Planning Commission Staff Report

Consideration of a Preliminary Plat application for the Northridge Estates subdivision consisting of 19 lots in the RA-2 and A-2 zones.

NORTHDRIDGE SUBDIVISION, PLAT 'A'

MAPLETON CITY DEVELOPMENT REVIEW COMMITTEE MINUTES

UTILITY PLAN

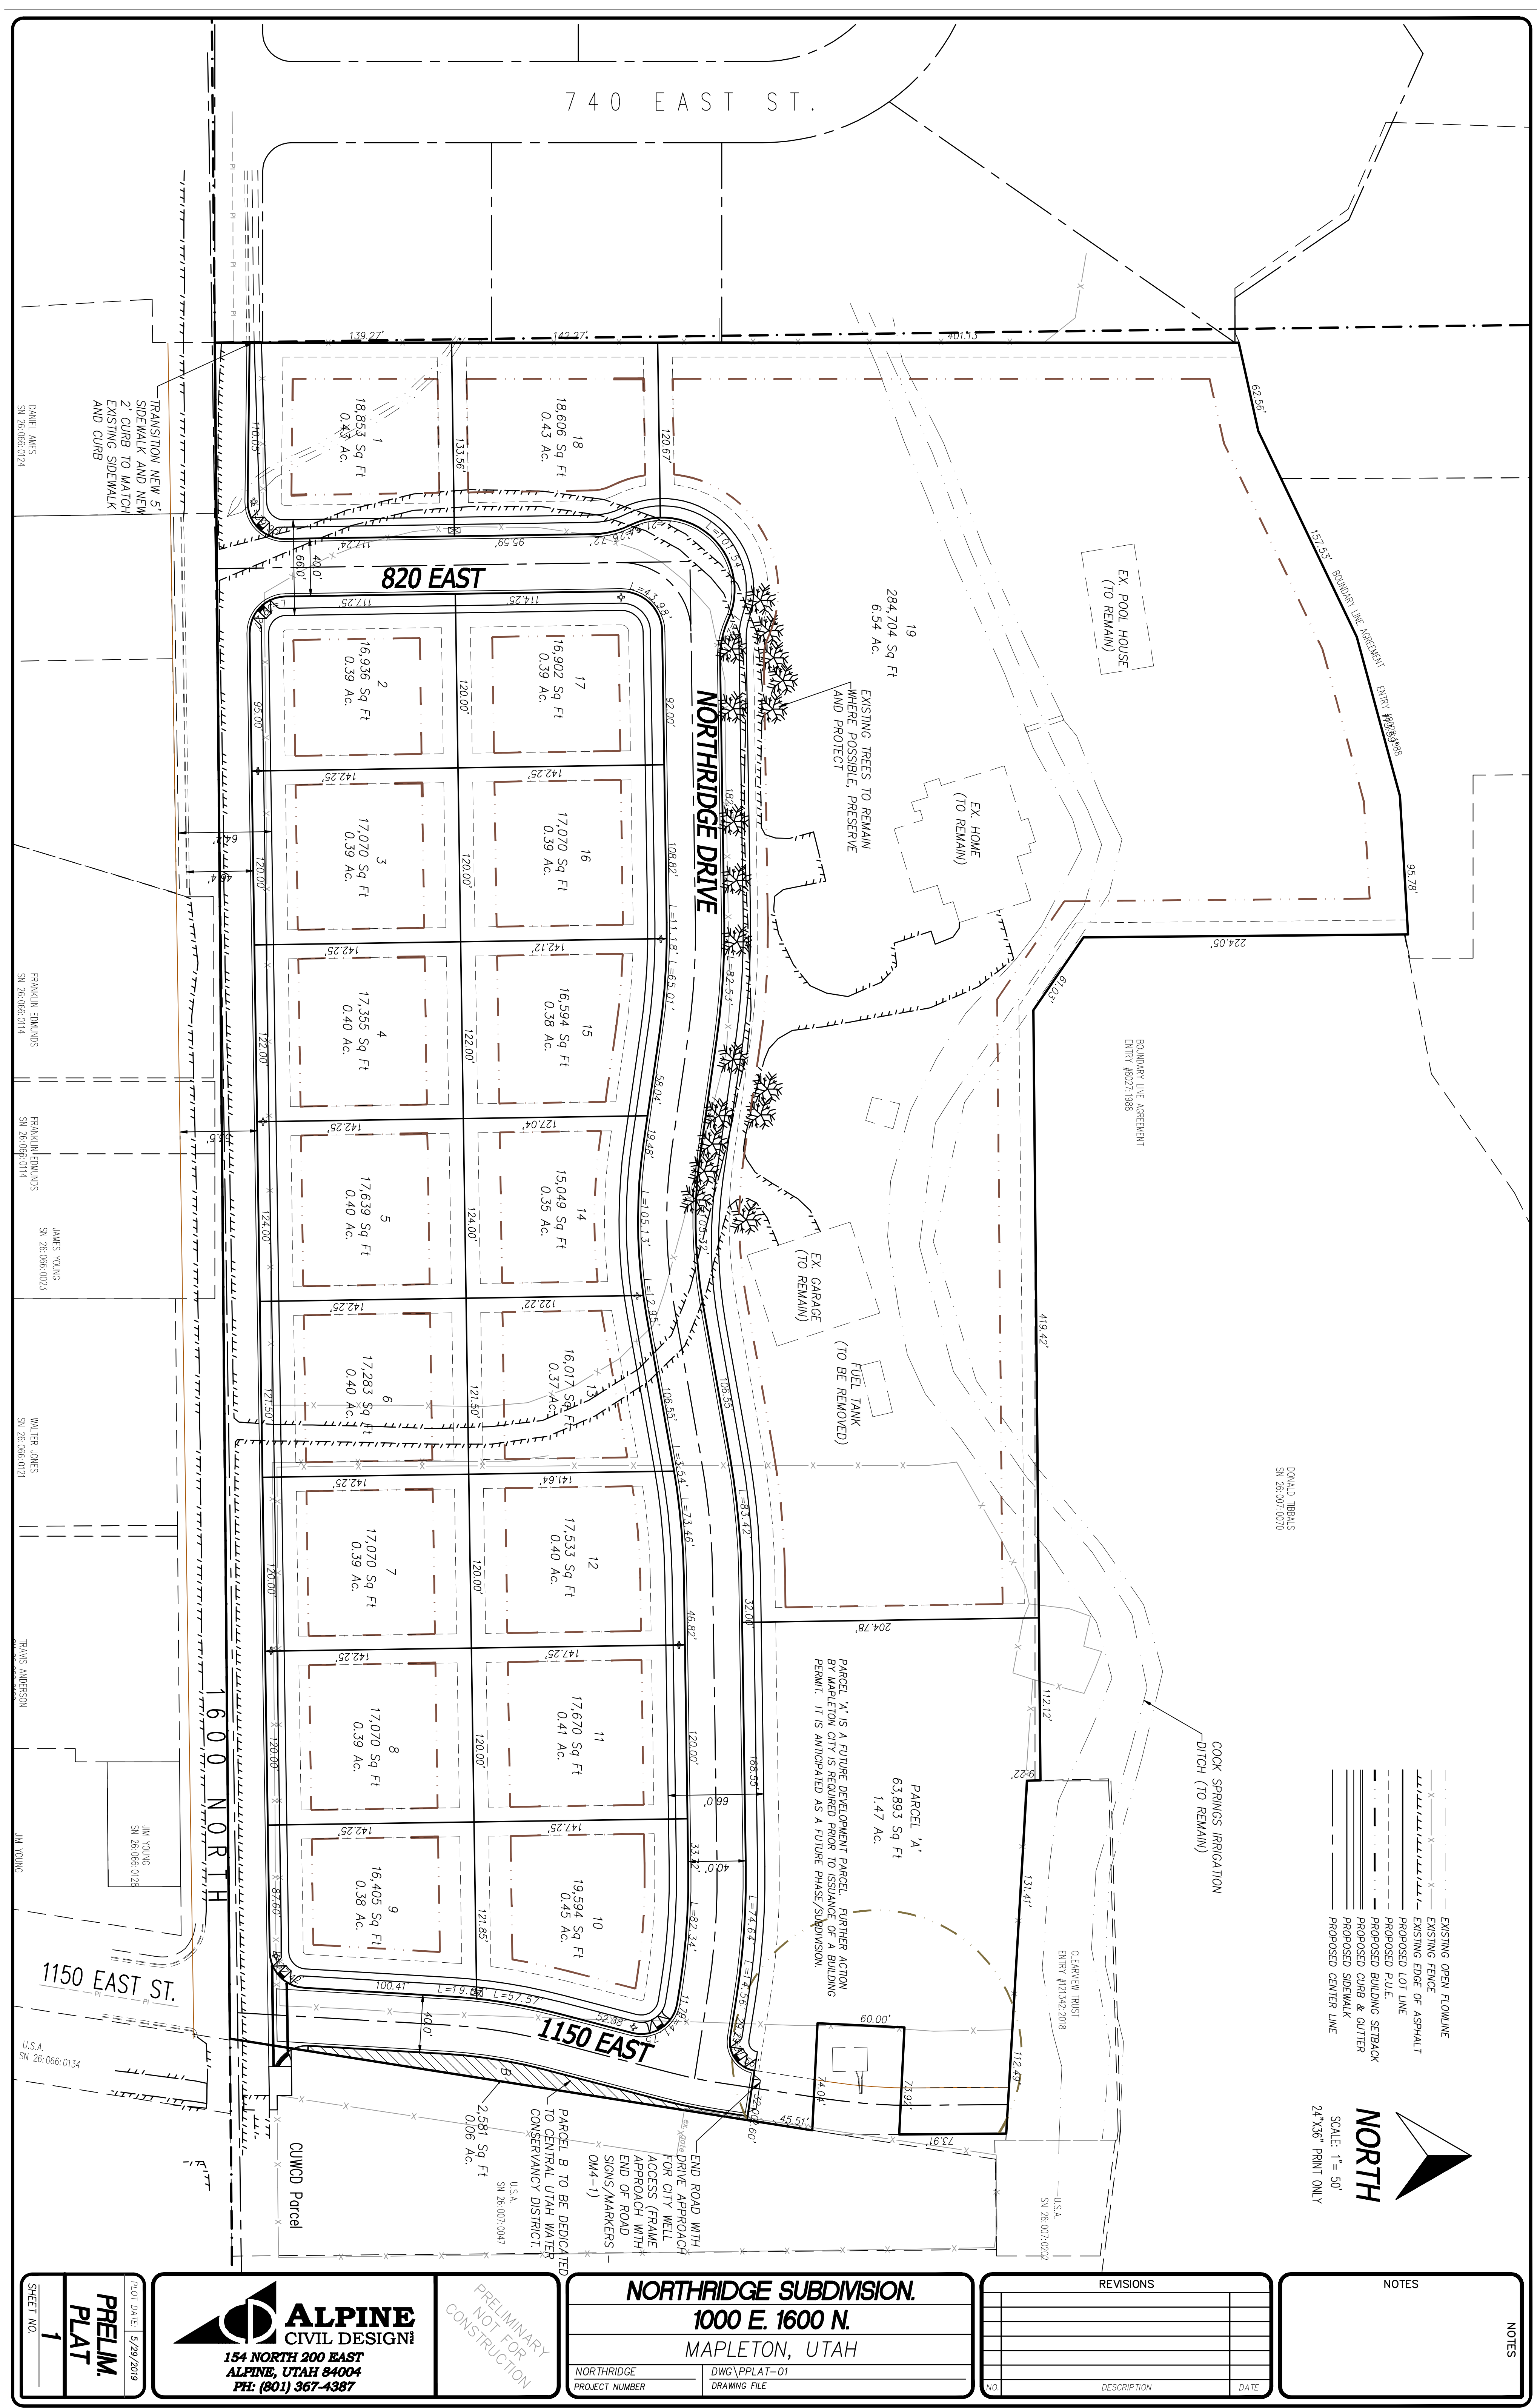
1. Valves will need to be installed immediately adjacent to tees/crosses on water mains. (Can be handled during construction).
2. There is water meter to the pool and the bard which may not be identified on the plans, they need to be removed/upgraded during construction.
3. Please show that existing sewer and water laterals must be disconnected at the main with detail.
4. All sewer lines within the source protection zone 2 of the Mapleton City well must be constructed to conform to Utah Administrative Code [R309-515-6.4](#).
5. The area around the Carnesecca Well shall comply with the source protection requirements identified in Mapleton City Code Chapter 13.28.
6. A revised easement shall be required to provide access to the Carnesecca with the plat recording.
